**RESTORATION OF THE  
JEFFERSON Co. COURTHOUSE**  
PHASE 5 - MECHANICAL AND SAFETY UPGRADES

ADD#1-1

SECTION 004990 – Contractor Evaluation – revised  
SECTION 23 0593 – Testing Adjusting and Balancing - revised  
Sketch ADD.#1-1 for additional roof repair detail

Sheet No.:  
**E-401**  
SHEET: OF:

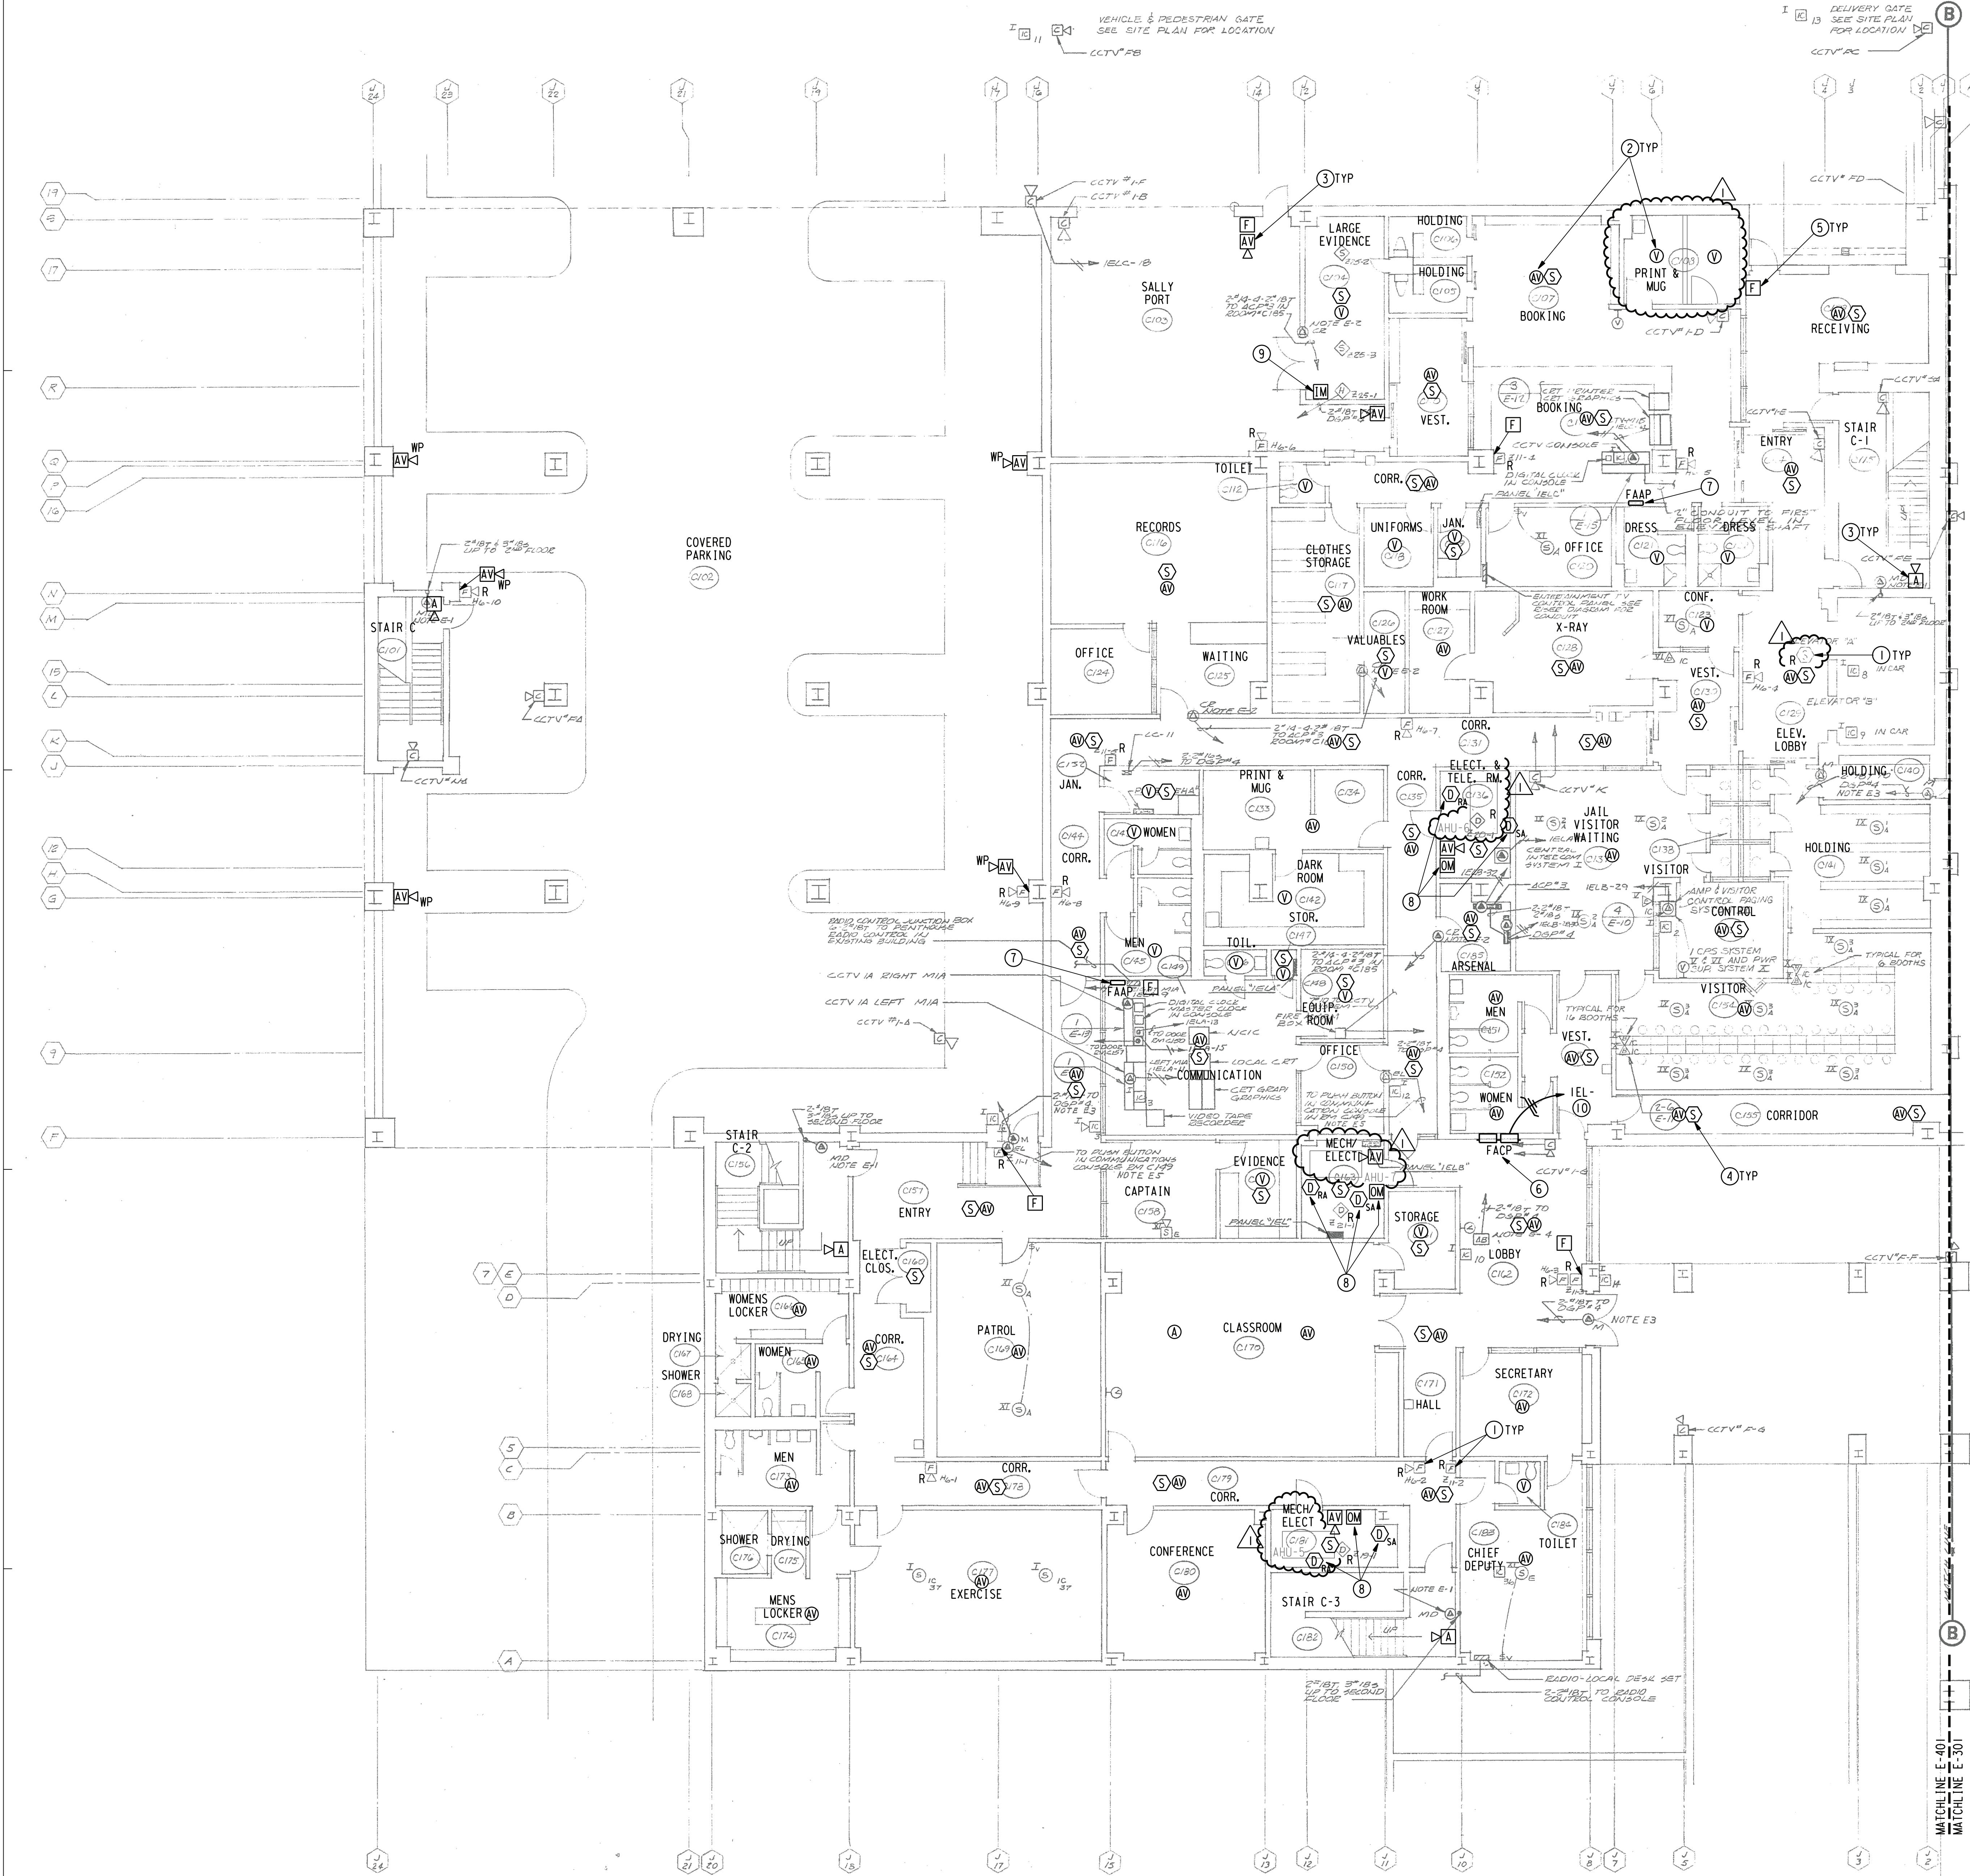
9. Clarification to Sheet E-401: the space labeled “Print & Mug Room C108” has been revised to show 2 separate rooms. A "V" device has been included in each of the two rooms.

Sheet No.:  
**E-402**  
 SHEET: OF:

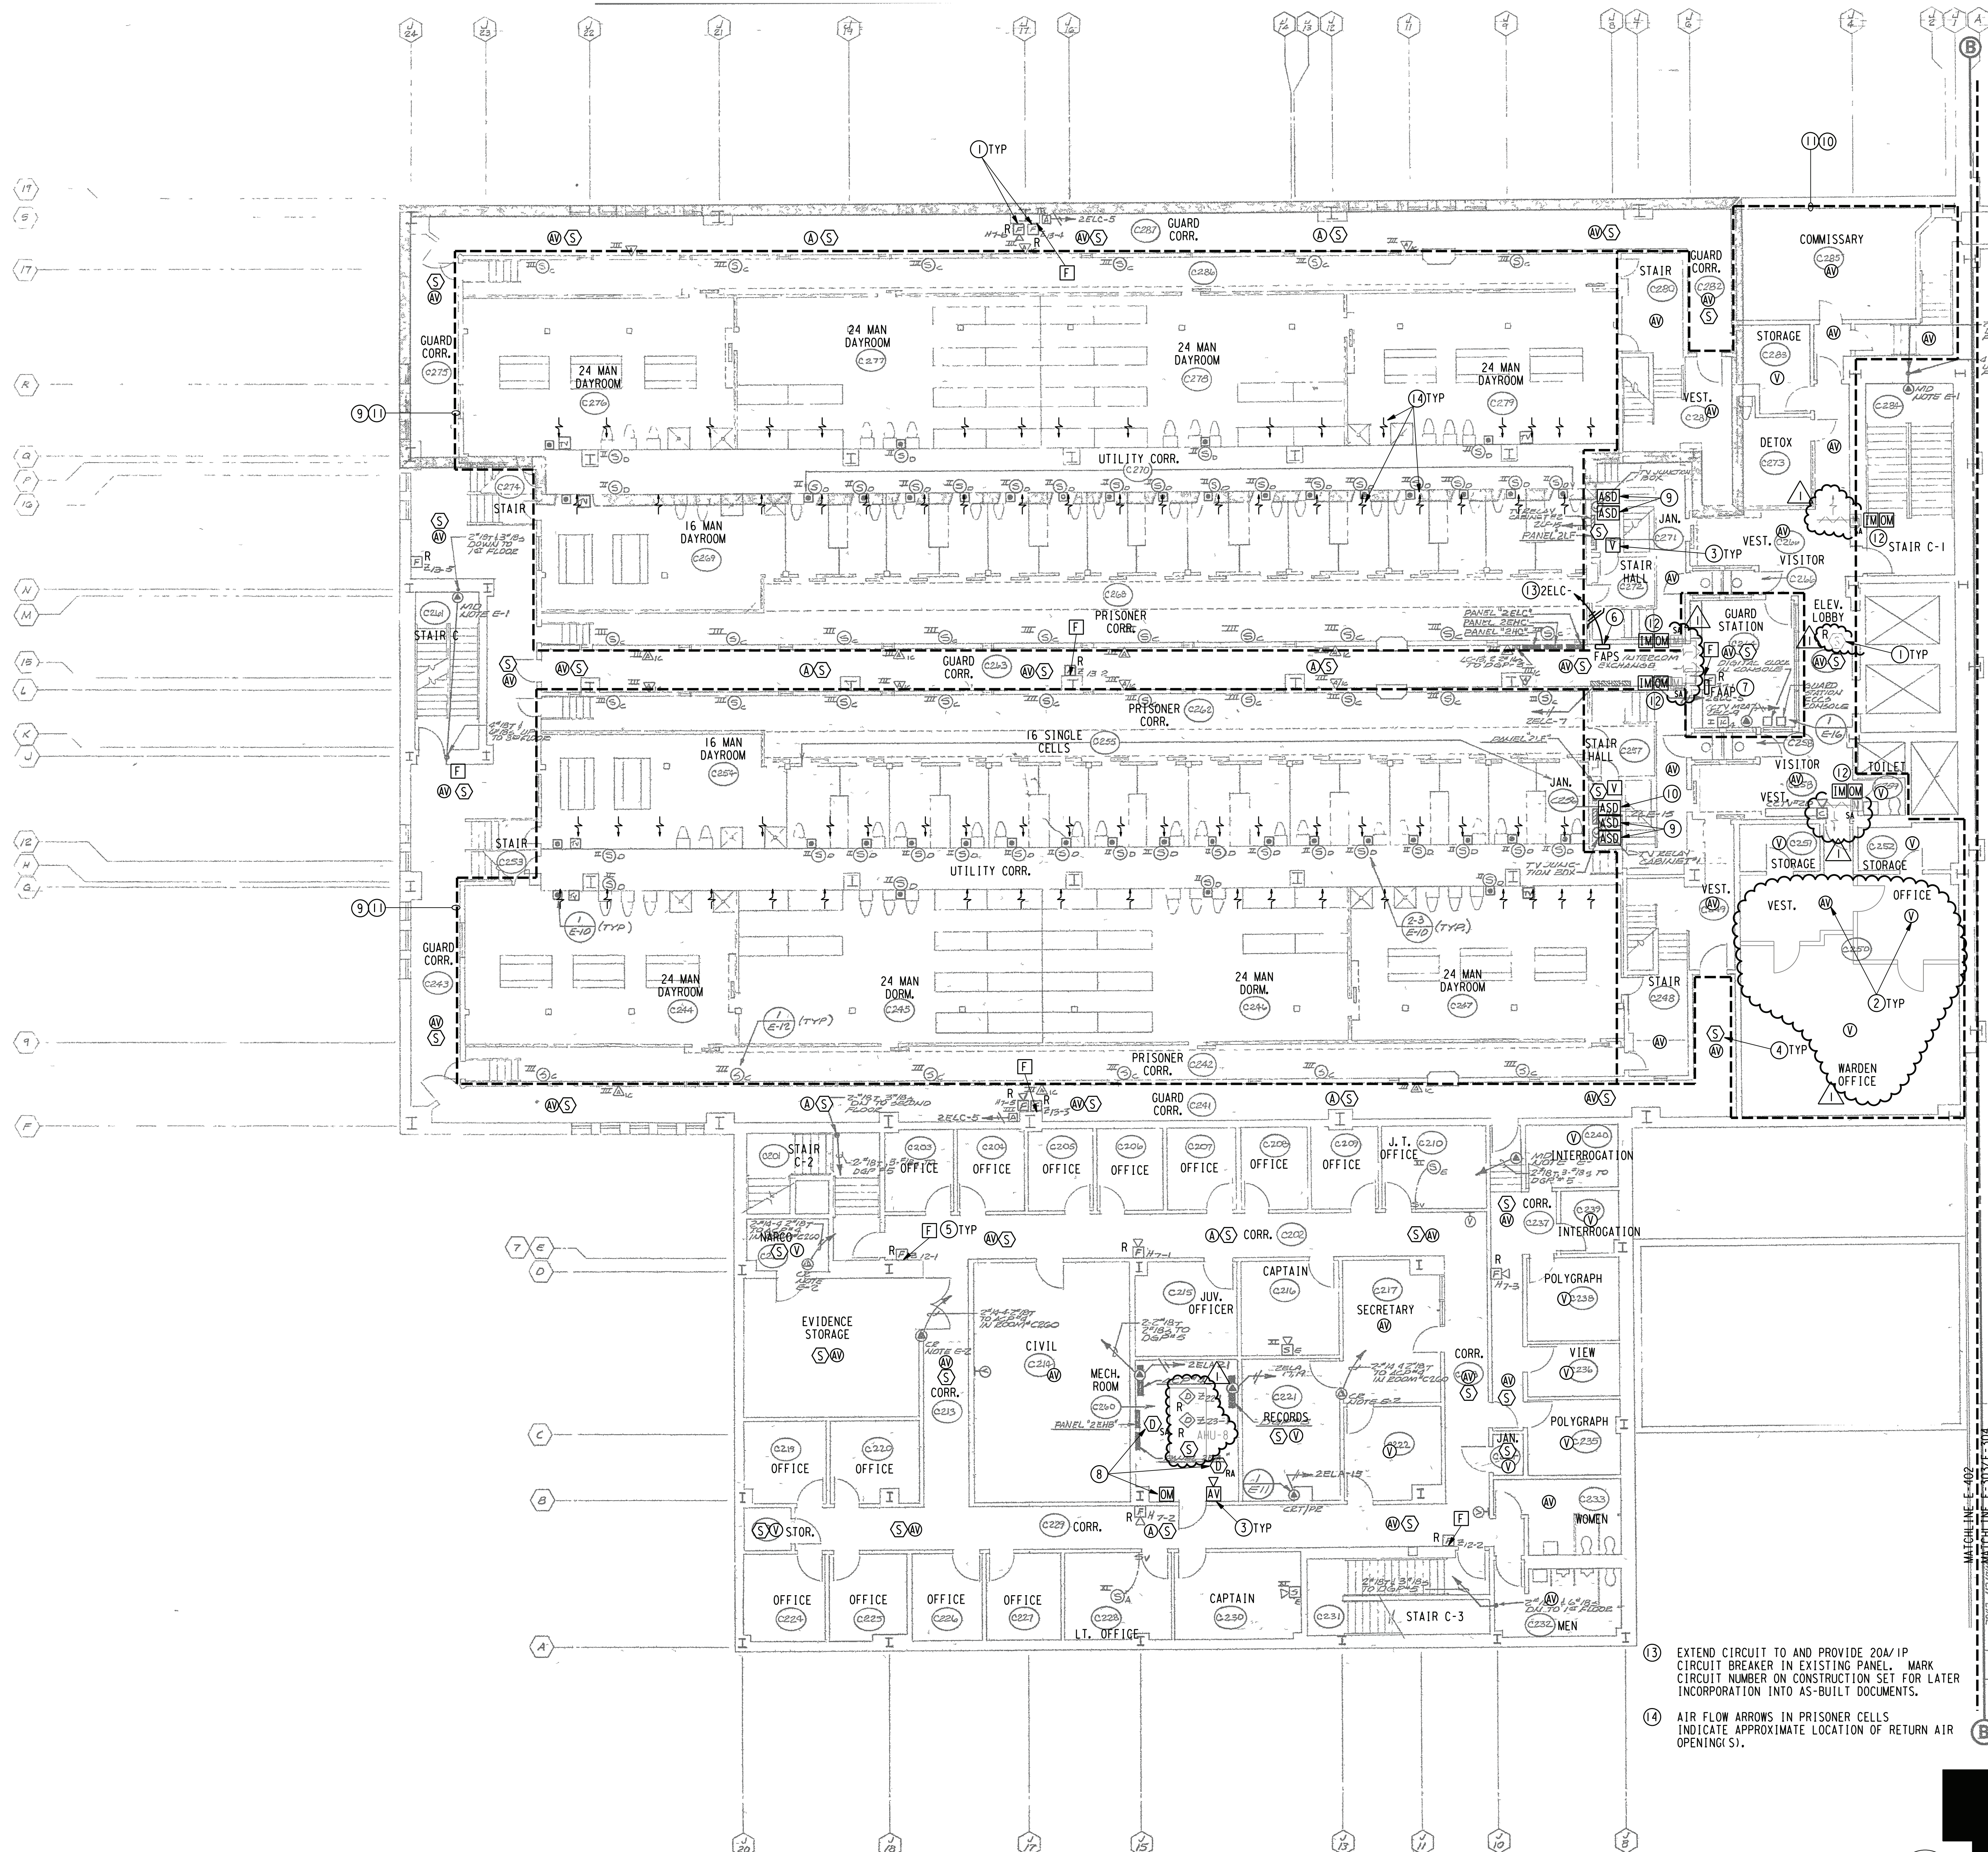
10. Clarifications to sheet E-402:
  - a. The areas indicated by notes 9 and 11 are to be covered by the air-sampling smoke detection system with sampling tubes in the utility chase behind the holding cells.

12. Refer to updated electrical drawing sheets for locations of controls for purge fans and dampers.
13. The room indicated to be MULTI-PURPOSE has been renovated into several offices and the Warden's office. Refer to revised sheet E-402.

Sheet No.:  
**E-404**  
 SHEET: OF:

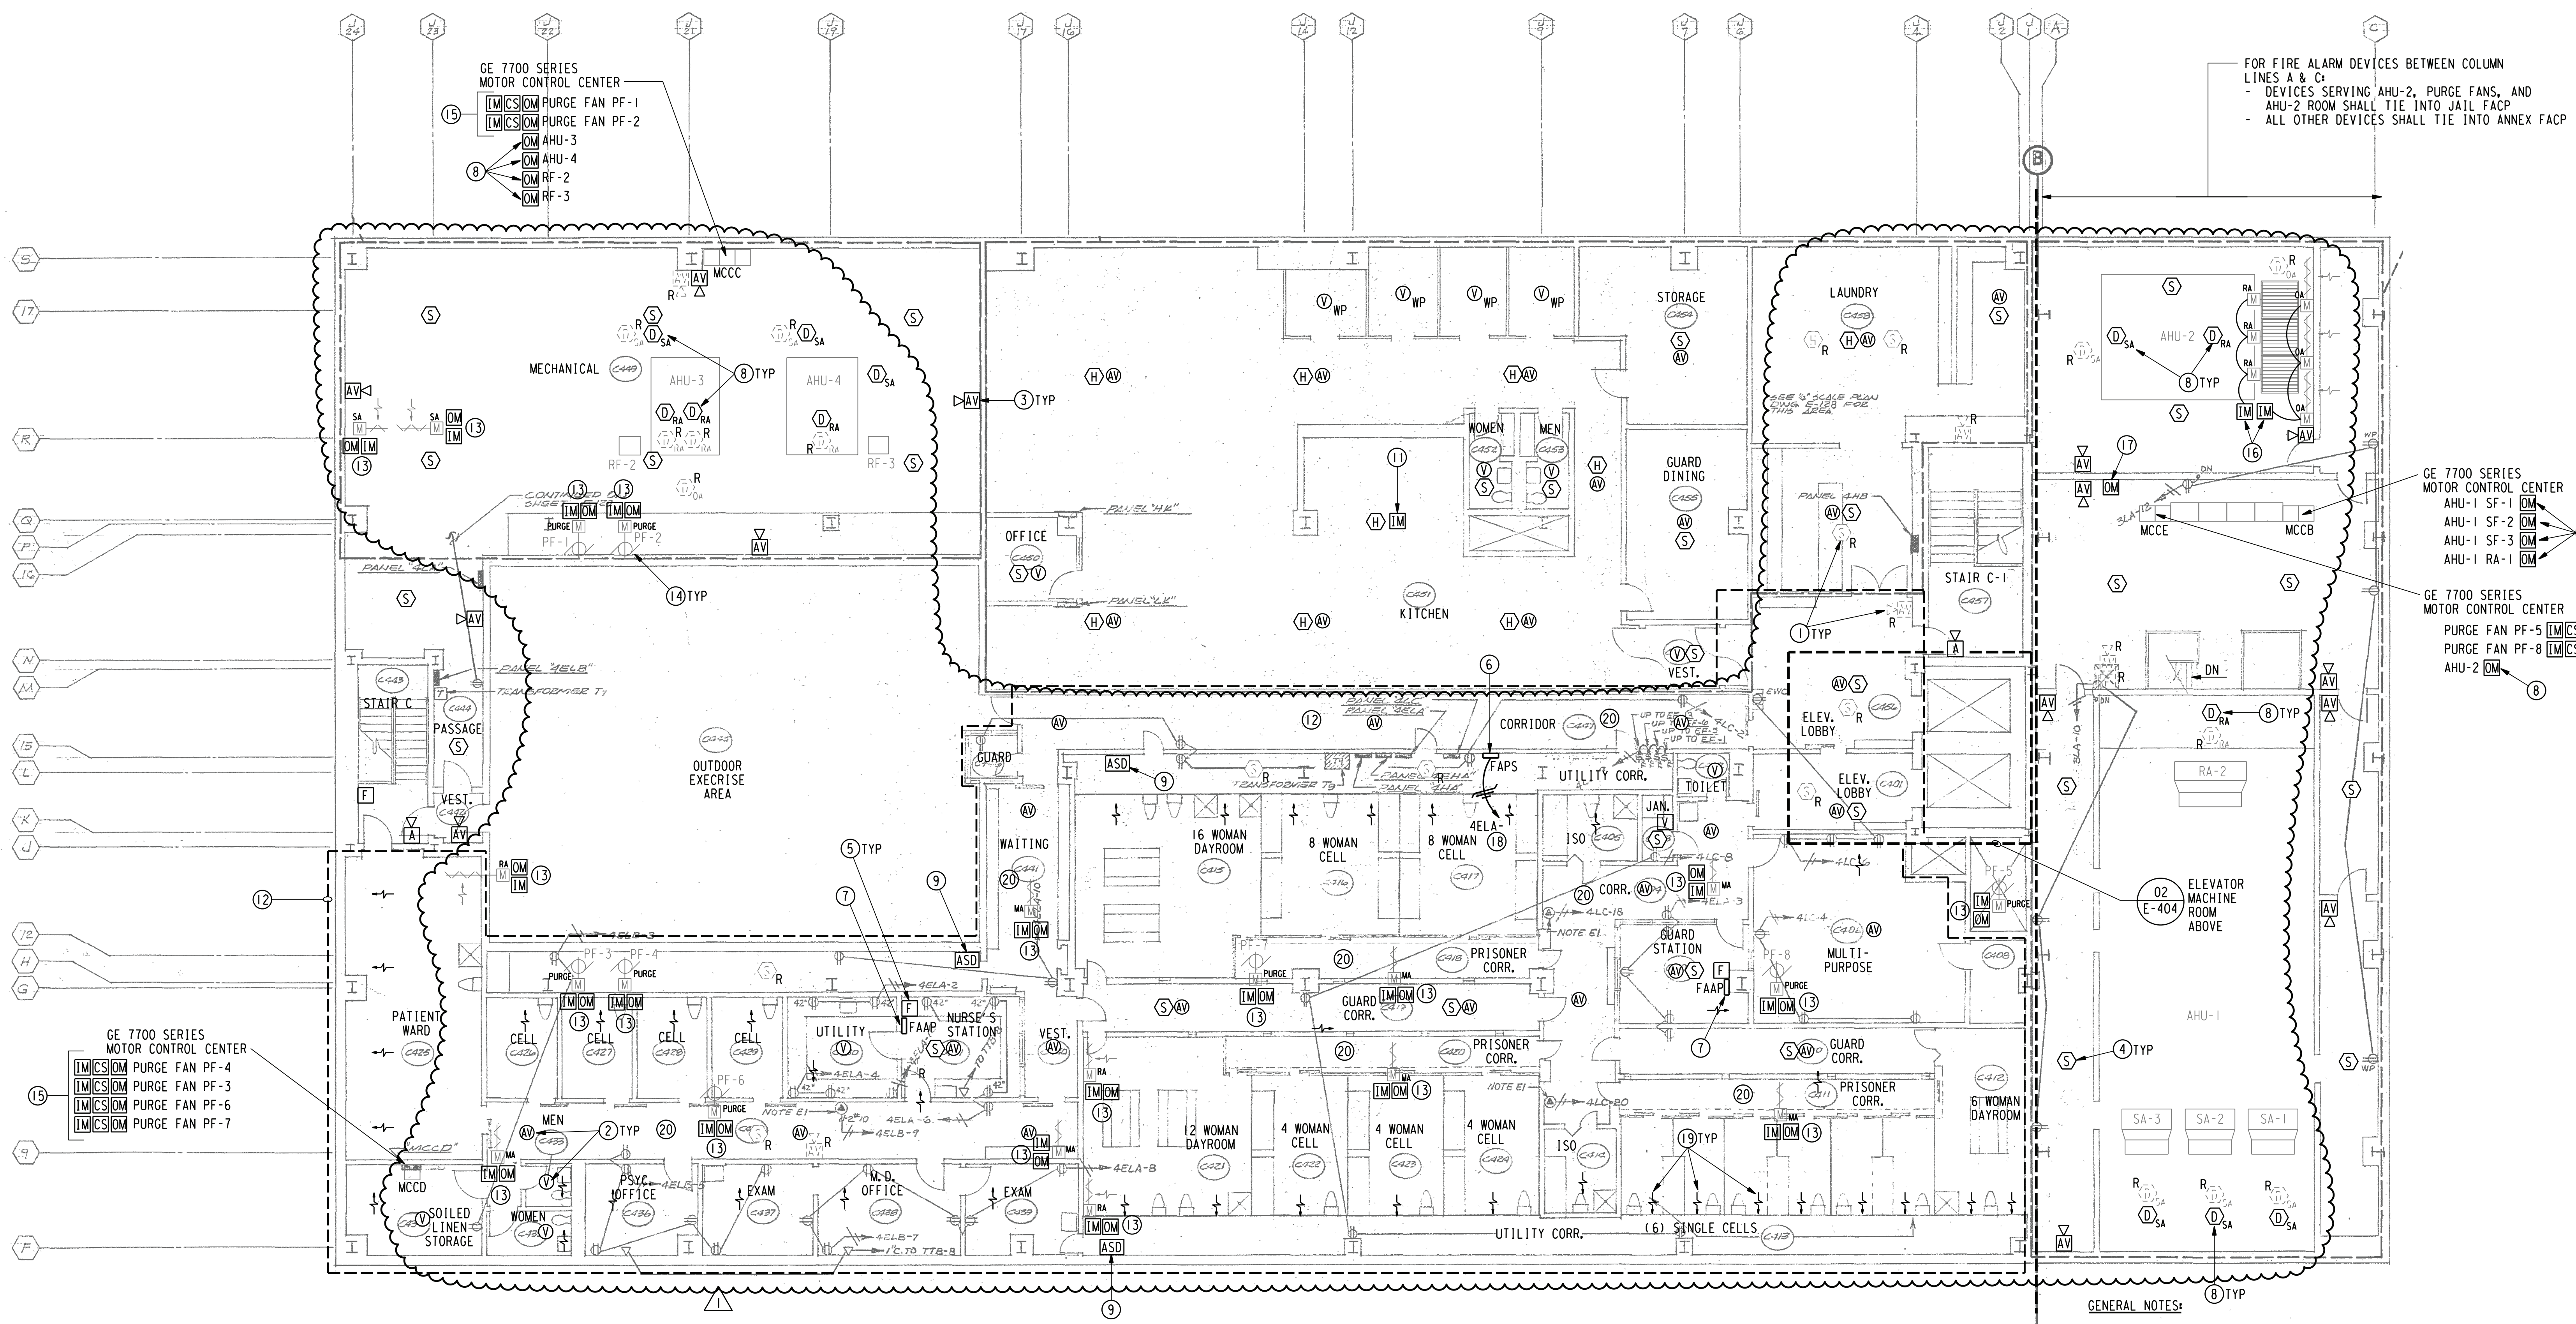
11. Clarifications to sheet E-404 :
  - a. The dishwasher hood does not require fan shutdown.
  - b. No devices are required in the 6 WOMAN DAY ROOM.
  - c. A strobe device is required in the Patient Ward. Smoke detection is to be via the air-sampling smoke detection system.
